Re: S/D 86-12 - Final Plat of Rock Park Second Addition.

ROCK PARK SECOND ADDITION

FINAL PLAT

**Final Plat
SUBDIVISION REPORT**

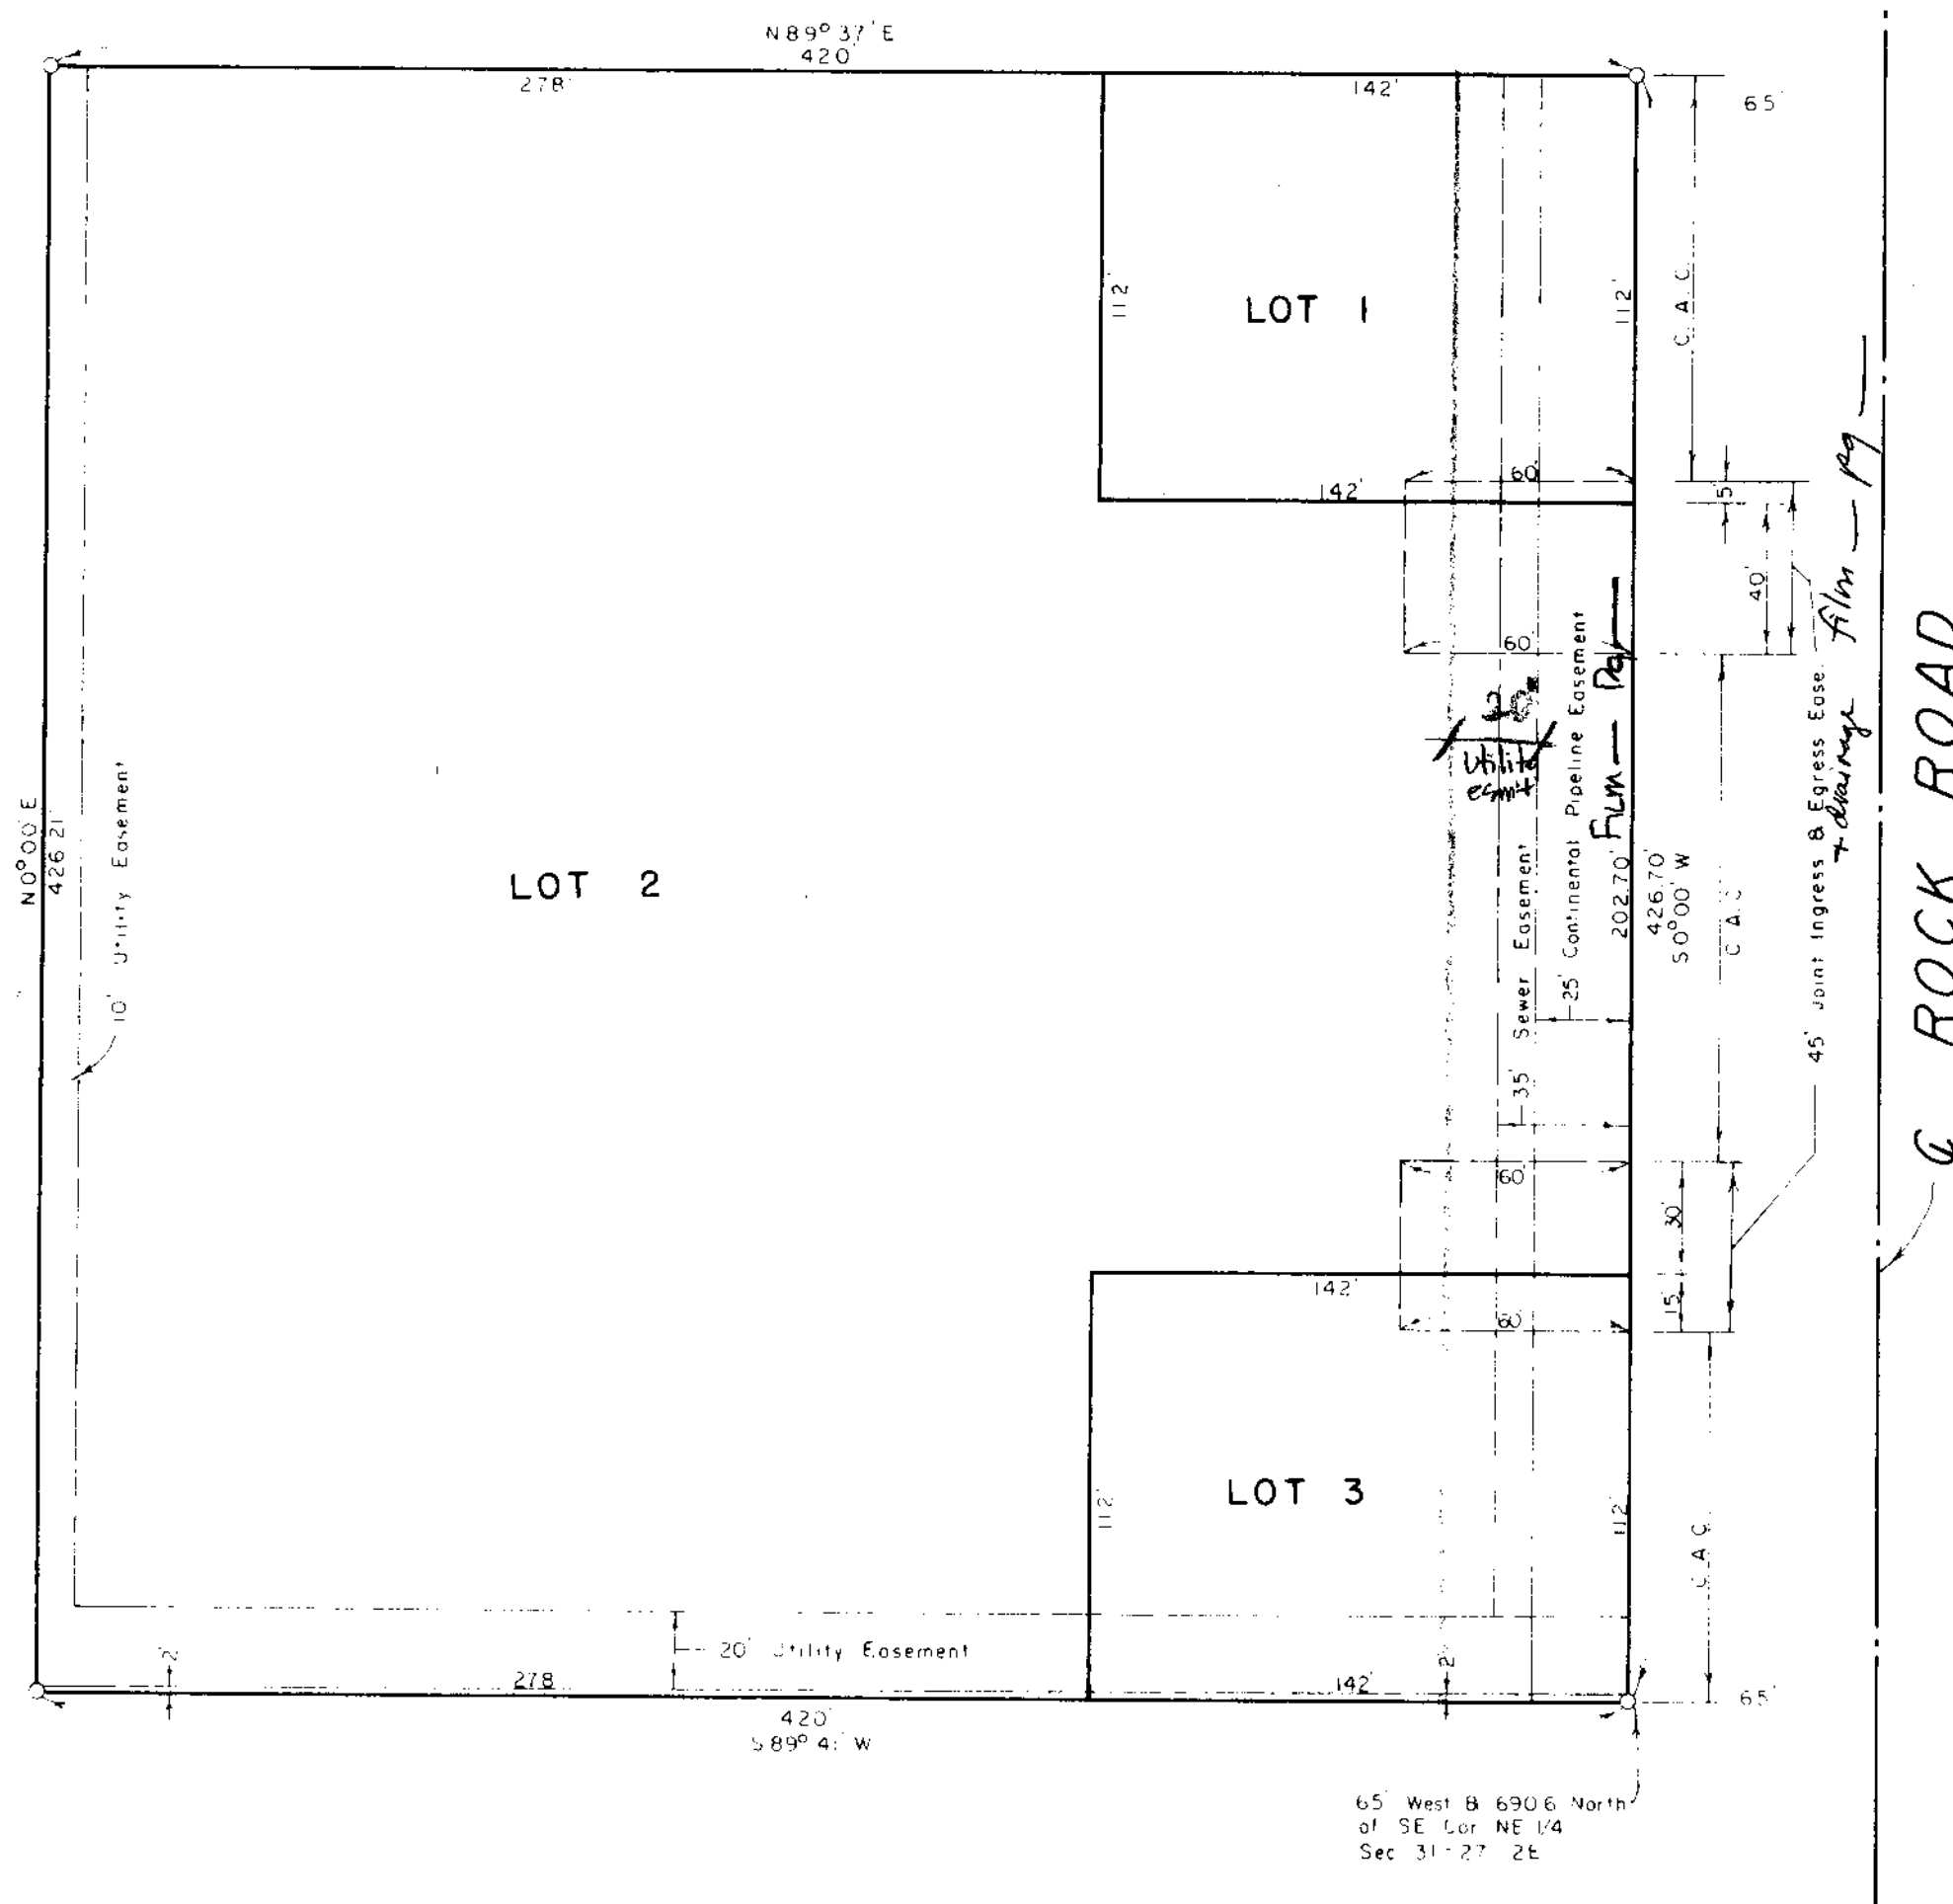
- J. Perimeter closure computations shall be submitted with the final plat tracing. Section 5-101(C).
- K. Recording of the plat within 30 days after approval by the Board of City Commissioners.

- L. The representative from the City Engineer's office should be prepared to comment on the status of the applicant's drainage plan. Specifically, are any drainage guarantees required by this replat?

- A.** The applicant shall guarantee the extension of sanitary sewer to serve the lots being platted.
- B.** The applicant shall guarantee any drainage improvements required by the platting of this property.
- C.** If improvements are guaranteed by petition, a notarized certificate listing the petitions shall be submitted to the Planning Department for recording.
- D.** On the final plat tracing, the wording in the platlor's text shall be amended to more clearly reference the access control being granted and shall state that the permitted openings to Rock Road shall be determined by the City Engineer. The following wording is suggested:

"All abutter's rights of access to or from Rock Road over and across the east line of the plat, except at the location of the joint ingress/egress easements shown on the face of the plat, are hereby granted to the City of Wichita, Kansas. The location of the one (1) permitted driveway within each of the two access easements shall be determined by the City Engineer.

- E.** The proposed 45-foot joint ingress and egress easements to serve Lots 1 and 2, and Lots 2 and 3 will need to be established by separate instrument with appropriate recording information indicated on the final plat tracing. Prior to recording the joint access easement, a draft shall be submitted to the Planning Department for review and approval. The instrument must clearly state the purpose of the easement, as well as which properties benefit from the easement. Initial construction responsibilities and future maintenance of the driveway within the easement should also be addressed by the text of the instrument.

- F.** Since existing access control to Rock Road is being vacated by this replat, the final plat tracing shall make reference to the vacation of access controls by virtue of K.S.A. 12-512(b).

- G.** The final plat tracing shall reference, on the face of the plat as well as in the platlor's text, that building setbacks are per the requirements of the Rock Road Commercial Community Unit Plan (DP-84) on file with the Wichita-Sedgwick County Metropolitan Area Planning Department.
